UNITED STATES **DEC 10 2019**
DEPARTMENT OF THE INTERIOR
BUREAU OF LAND MANAGEMENT
DISTRICT/ARTESIA/O.C.D.
APPLICATION FOR PERMIT TO DRILL OR REENTER

5. Lease Serial No. NMNM018613A	
6. If Indian, Allottee or Tribe Name	
7. If Unit or CA Agreement, Name and No.	
8. Lease Name and Well No. NOEL HENSLEY FED COM 221H 326122

APPROVED WITH CONDITIONS
Approval Date: 12/08/2019

Figure 1. Cross-sections and plans for typical road sections representative of BLM resource or FS local and higher-class roads.

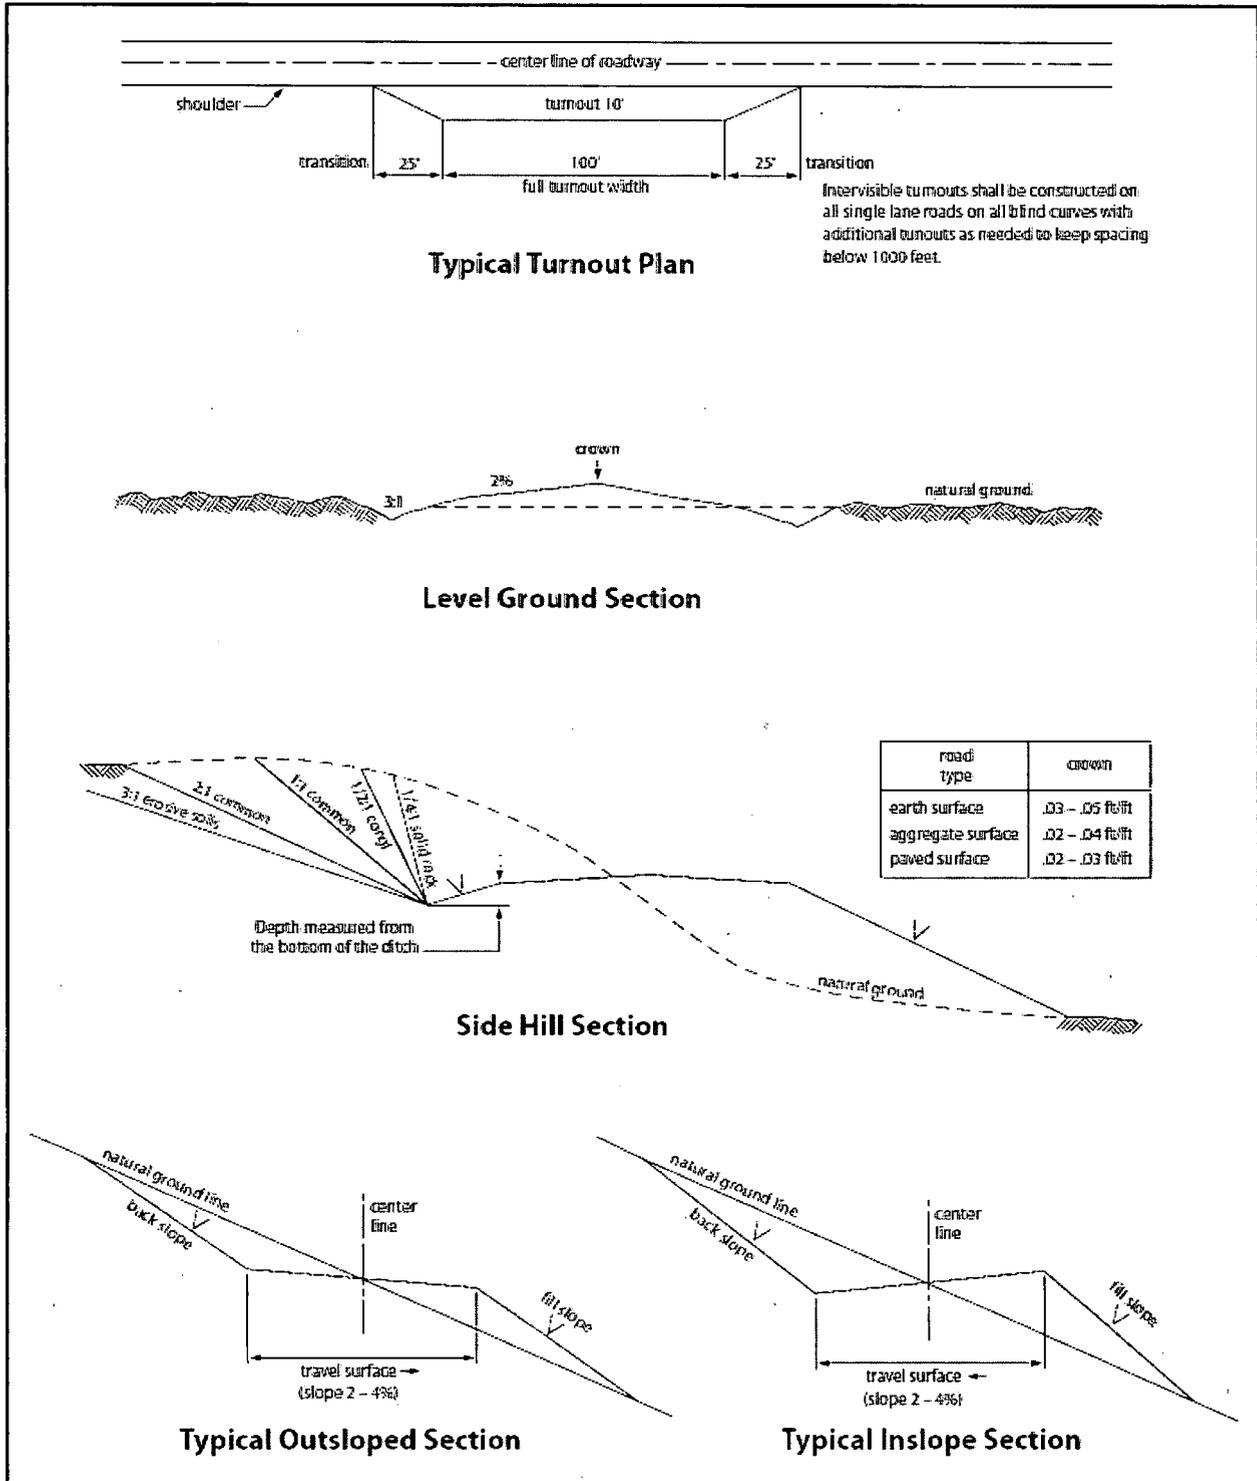
Crowning shall be done on the access road driving surface. The road crown shall have a grade of approximately 2% (i.e., a 1" crown on a 14' wide road). The road shall conform to Figure 1; cross section and plans for typical road construction.
